July 11, 2002

Subject: Oconee Nuclear Station
Docket Numbers 50-269, 50-270, and 50-287
License Amendment Request for Oconee Technical
Specifications
Technical Specification Change (TSC) Number
2002-04

Ocone Unit 1, 2, and 3 Technical Specifications and Bases

Marked Copy

Figure 3.4.11-1 (page 1 of 1)
Reactor Coolant DOSE EQUIVALENT I-131 Specific Activity Limit
Versus Percent of RATED THERMAL POWER With Reactor Coolant
Specific Activity $> 1.0 \mu\text{Ci/gm}$ DOSE EQUIVALENT I-131

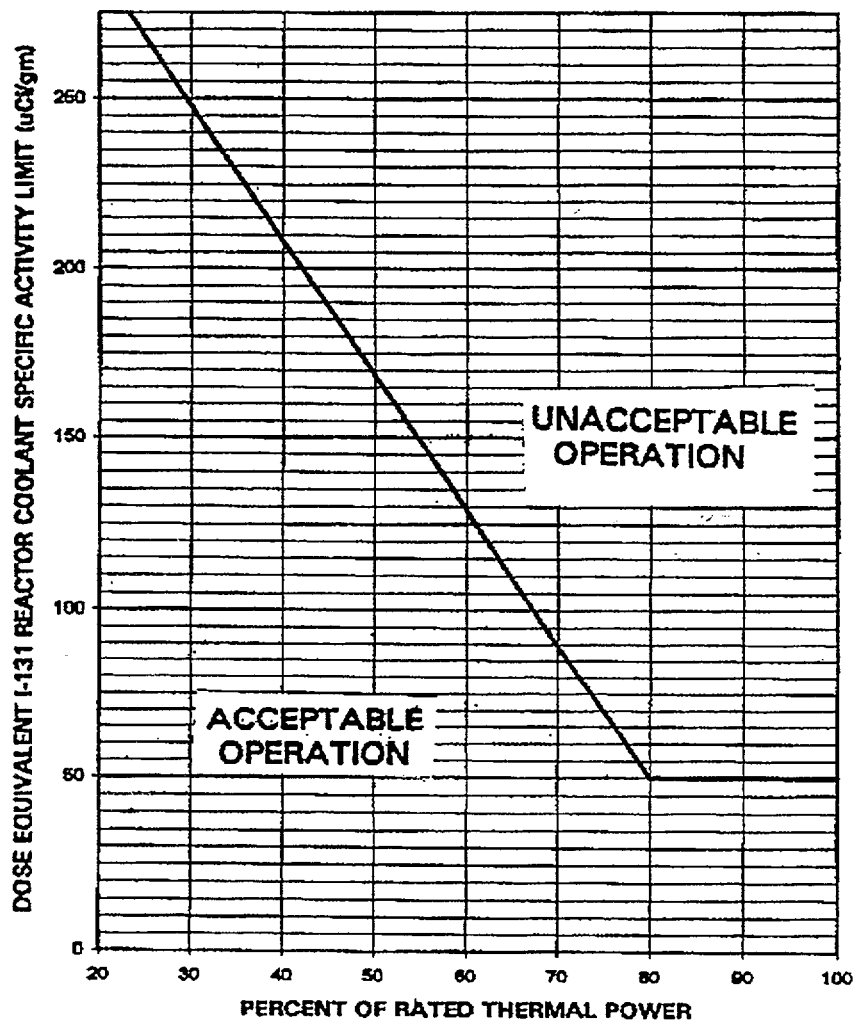
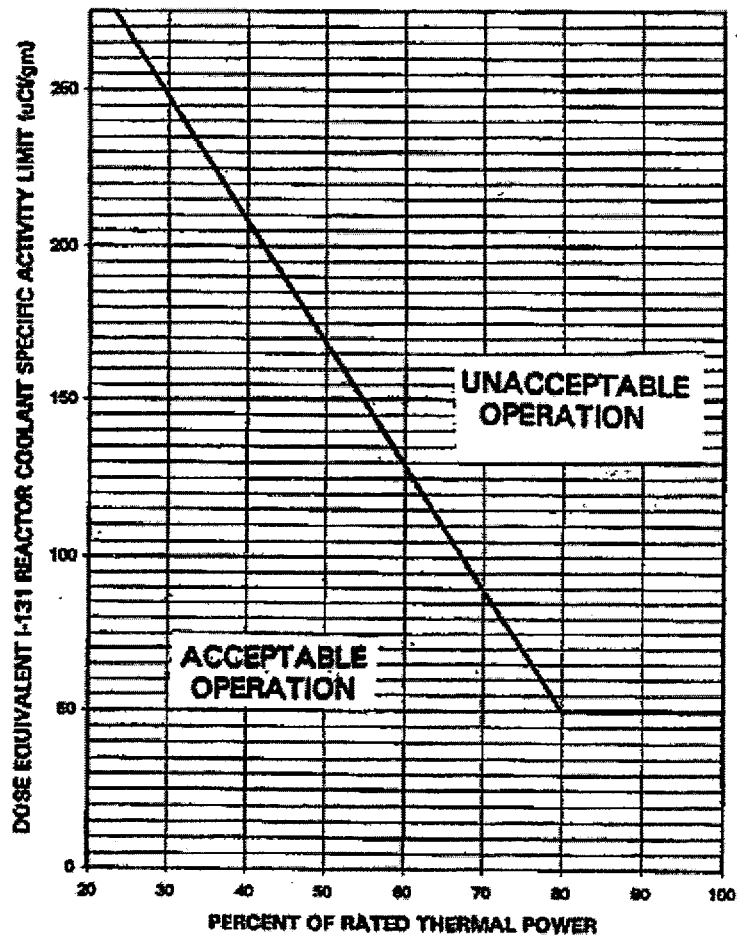
In Figure 3.4.11-1 (Page 1 of 1), the misspelled word "Termal" is being corrected to "Thermal." This change is solely administrative in nature.
